JAMESTOWN ENTRANCE PLAZA AND PARKING LOT IMPROVEMENTS

PROJECT CODE NUMBER: 425-16133
 JAMES CITY COUNTY, VIRGINIA

JAMESTOWN SETTLEMENT STORMWATER MANAGEMENT MASTER PLAN

JAMESTOWN
PHASE I - DRAINAGE IMPROVEMENTS
UTILITY PLAN

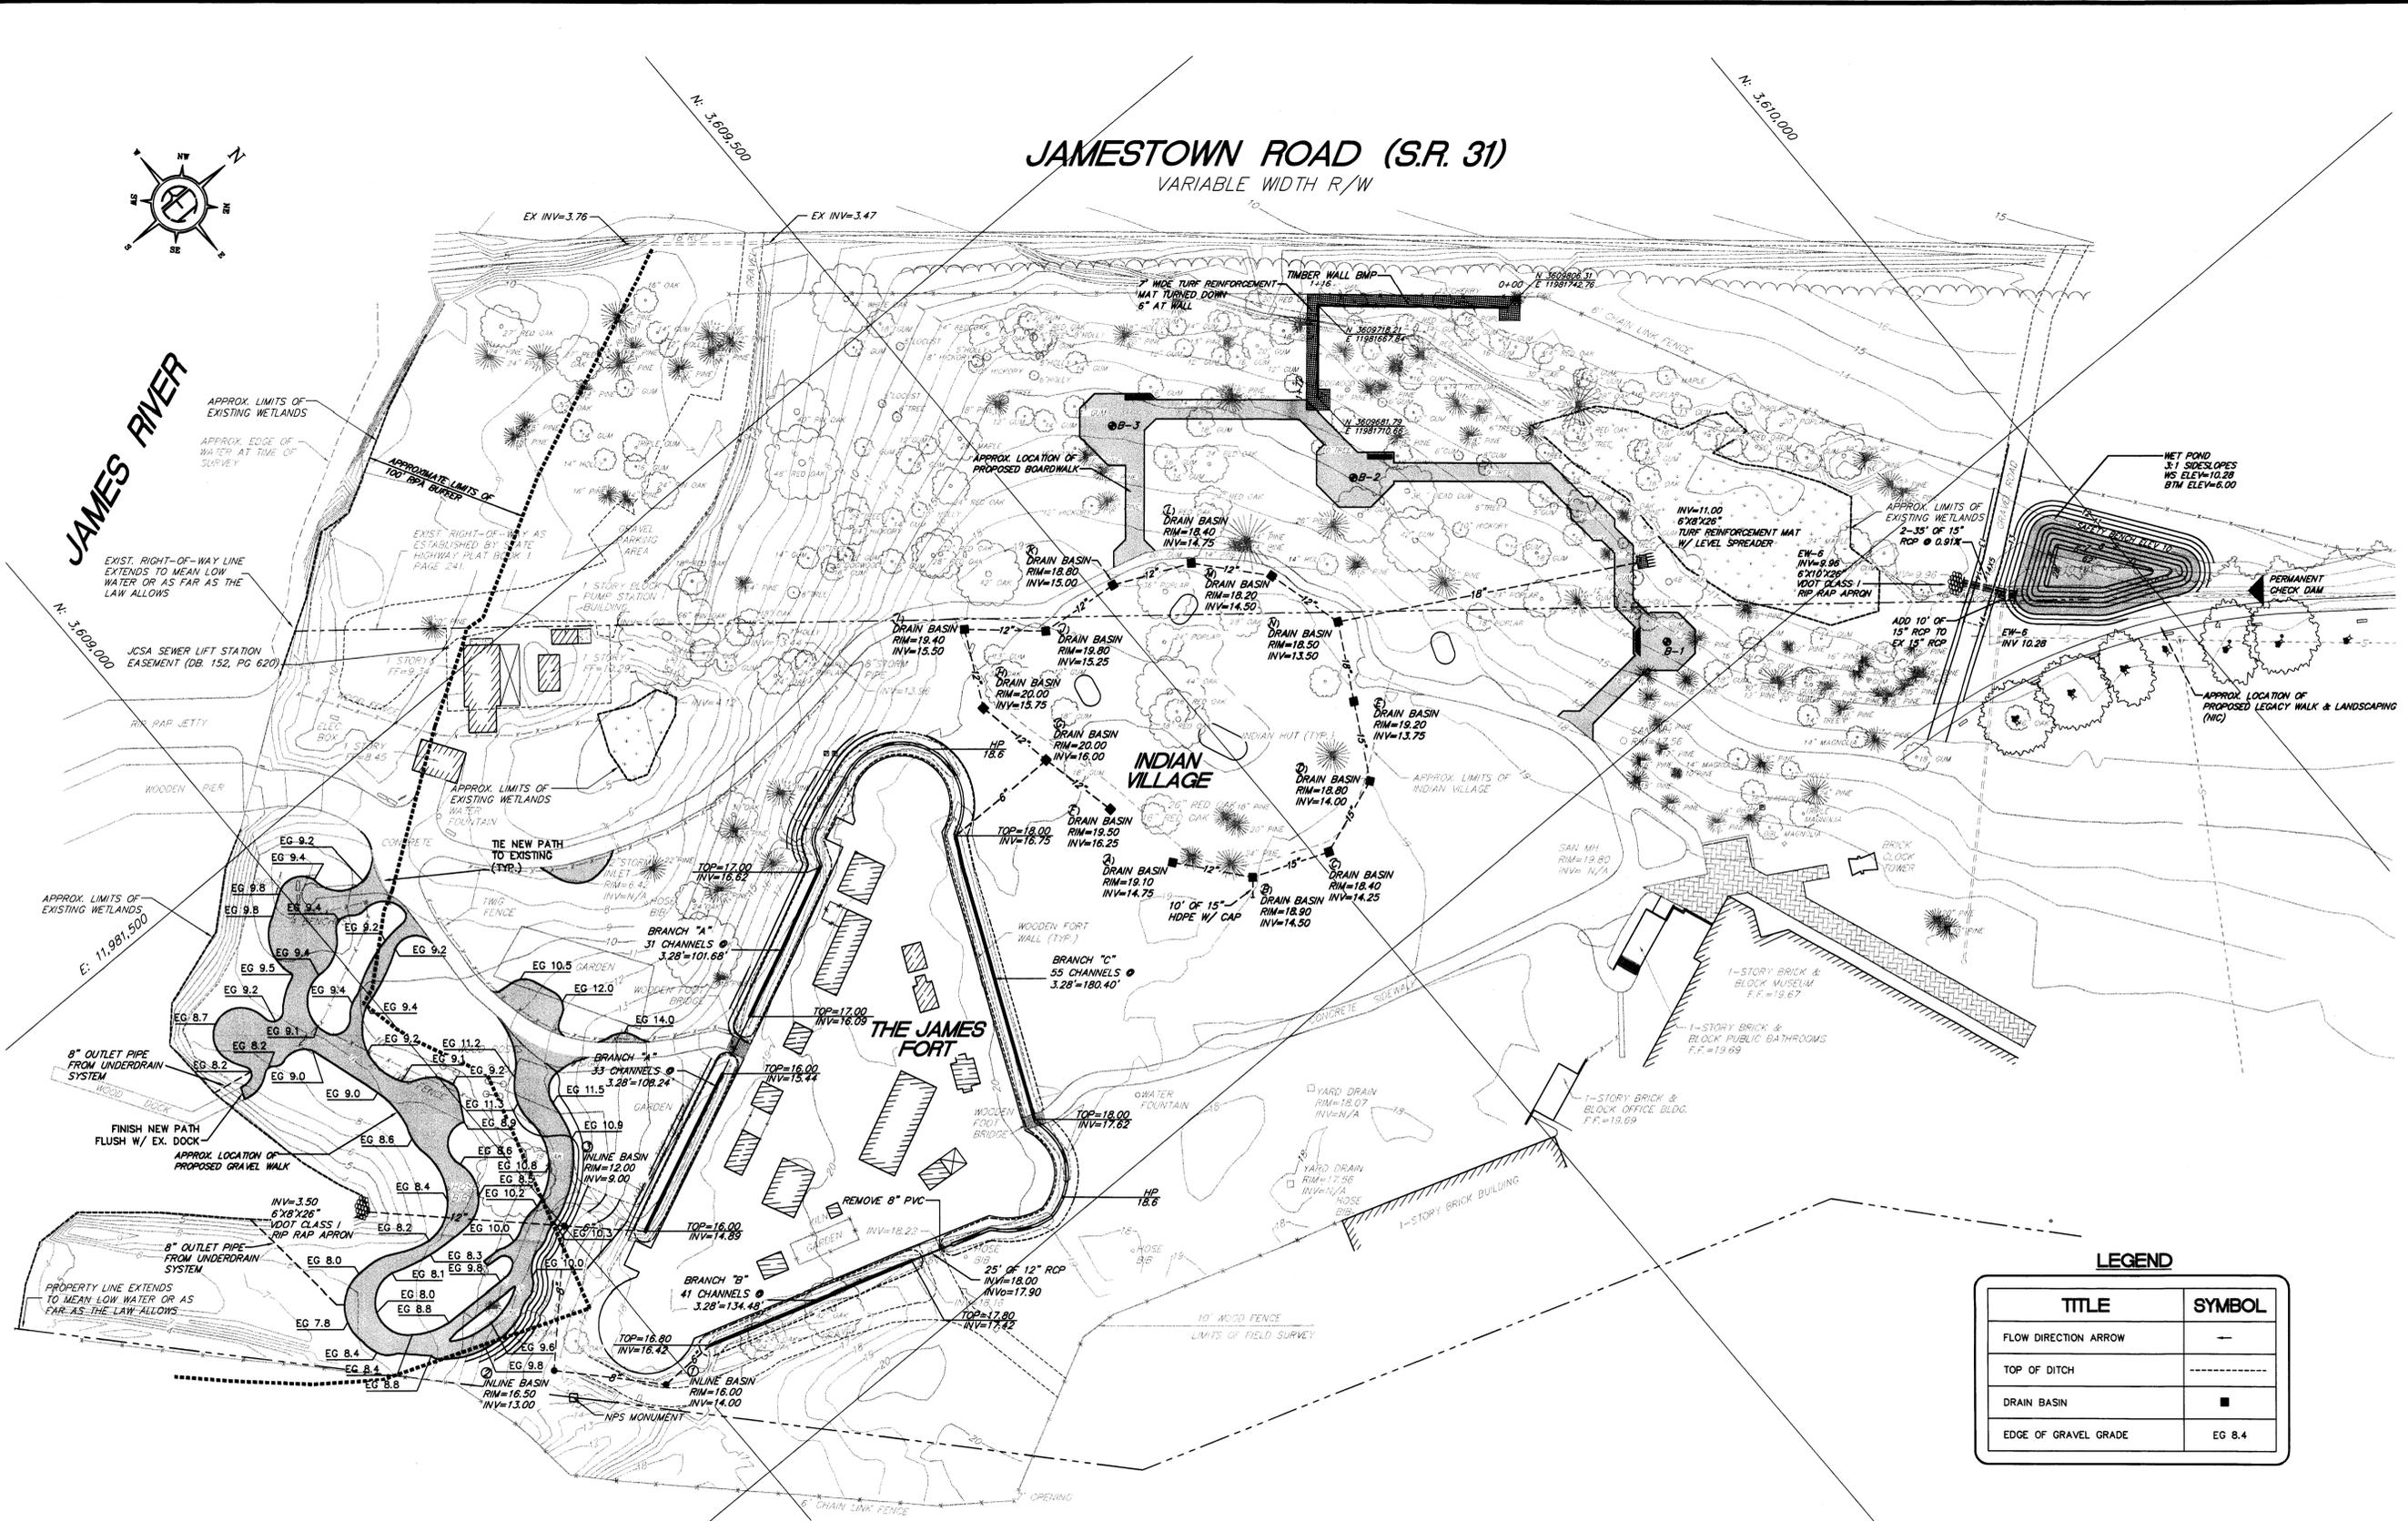
Show on the plan the location of the RPA. Provided on sheet C2+C3

Provide more information regarding the pond portion of the BMP. The upstream invert of the pipe needs to be specified and provided with a headwall or flared end section, something to support and protect the end of the pipe. Provided on sheet C2

Provide a rock check dam above the pond in the existing ditch to establish its use as a forebay for the pond/wetland system. Provided on sheet C2

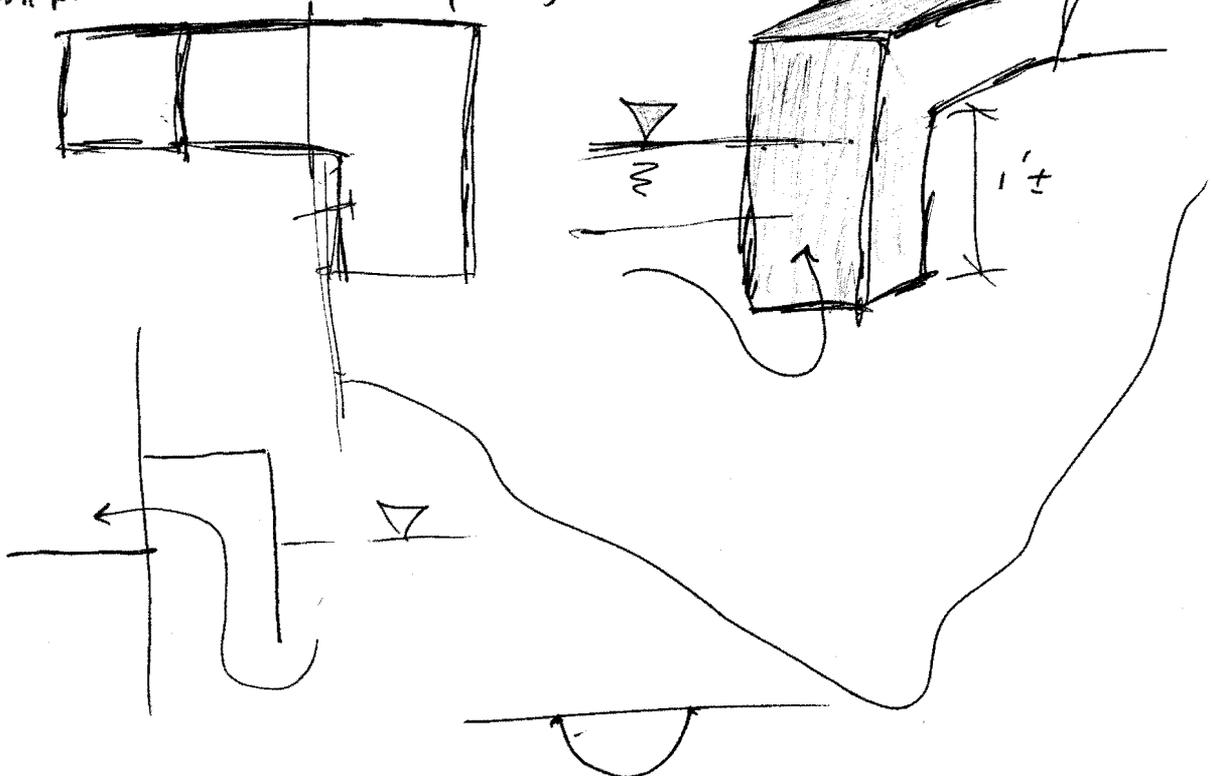
What about w/g release

- Rip rap dim. needed several places

- Protection for 7" opening
